# Work Order ID 86965

Item ID: D3183-045 Accept \*N900040100\* Setup Start \*NS1\*  
 Revision ID: Stop \*NS2\*  
 Item Name: Bearing Assembly  
 Start Date: 7/10/12 Start Qty: 30.00 \*30\* Cust Item ID:  
 Required Date: 8/10/12 Req'd Qty: 30.00 \*30\* Customer:  
 Reference:

DESIGN #	DRAWN BY CP	<b>DART AEROSPACE LTD</b> HAWKESBURY, ONTARIO, CANADA	
CHECKED #	APPROVED #	DRAWING NO. <b>D3183</b>	REV. C SHEET 1 OF 4
DATE <b>04.02.17</b>		TITLE <b>BRACKET ASSEMBLY</b>	SCALE 1:1
A	03.01.24	NEW ISSUE	
B	03.06.17	REMOVE BEARING; 1.012 WS 0.882	
C	04.02.17	ADD -045/-9; 0.182 WAS 0.431	
CI	04.11.09	0.830 WAS 0.850

DRAWING NO. D3183	TITLE BRACKET ASSEMBLY	REV.C1	DART AEROSPACE LTD ENGINEERING ORDER		D.E.O. NO. D3183-C1-1	SHEET NO. SHEET 1 OF 1	SCALE NTS
DRAWN 90	CHECKED [Signature]	MFG. APPR. [Signature]	APPROVED [Signature]		DE APPR. [Signature]		
DATE 10.05.14	DATE 10.06.30	DATE 10.06.30	DATE 10/06/30		DATE 10/06/30

**D3183-5 BEARING:**  
**SPECIFICATION CONTROL DRAWING**

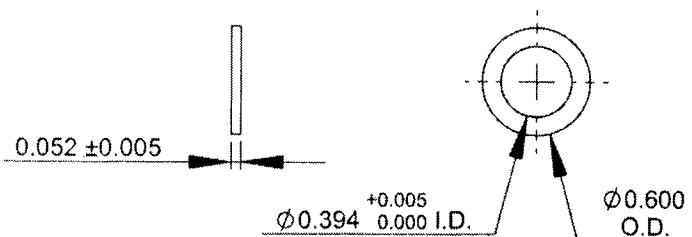
ADD POSSIBLE SUPPLIER: KML P/N 6800-ZZ

**BASIC LOAD RATING REQUIREMENT:** Cr = 1720 N (386 lb) MIN [DYNAMIC]  
Cor = 840 N (188 lb) MIN [STATIC]
